November 30, 2000
MFG Project No. 030062.1

**Subject: Work Plan for Investigation of Soil and Groundwater Within Utility Trench
Hertz Facility, 1 Airport Drive, Oakland, California [StID # 2260]**

SITE PLAN		
Hertz Service Center 1 Airport Drive Oakland, California		
Project No. 030082	By: N. Johnson	Figure 1
Date: 11/3/00	Checked: <i>ae</i>	
MFG, Inc. consulting scientists and engineers

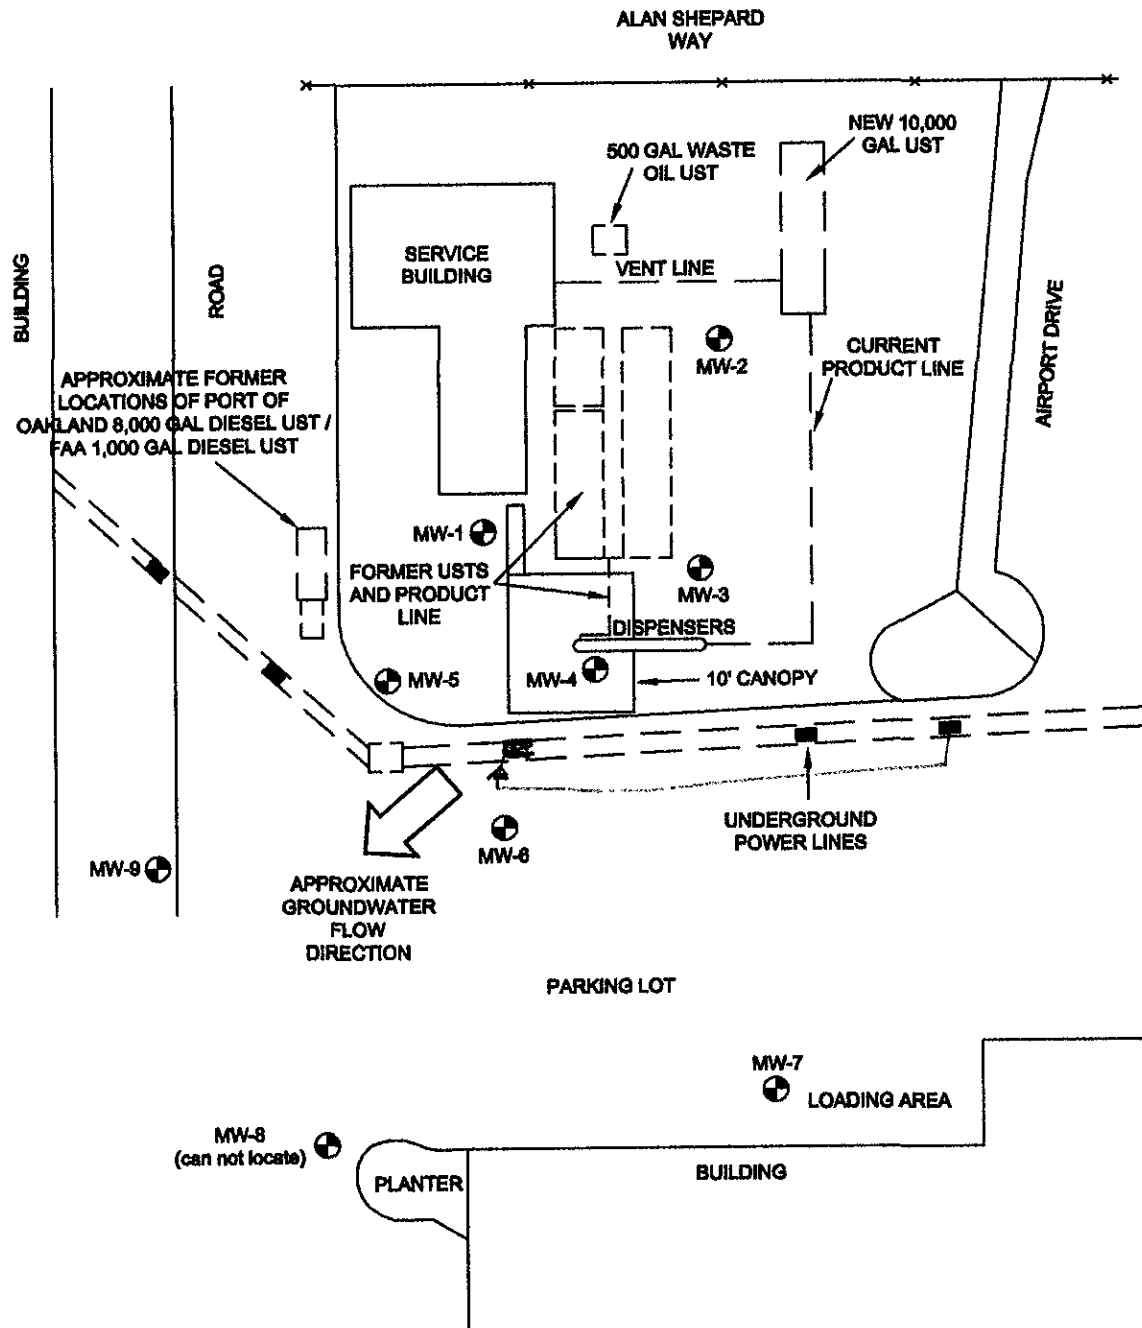
Need to sample
regard less

Need to collect
samples?
